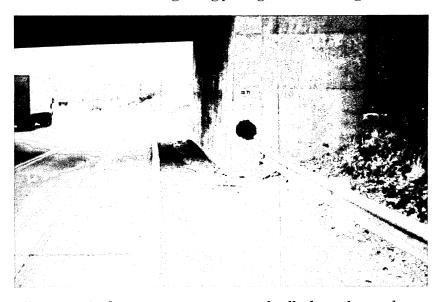
And here you see a guardrail installed wrong on the right-hand side. In the center barrier they had an excuse; they called it a center barrier so let's say the guy put it there. But here there is not any reason for this guardrail at all. They only reason it is there is to protect the bridge abutment. You can see it is guiding you right into the bridge abutment.

If you look close, you can see a scratch all along there, where a bumper hit this. They repaired it and put it right in the same place. This is wrong.
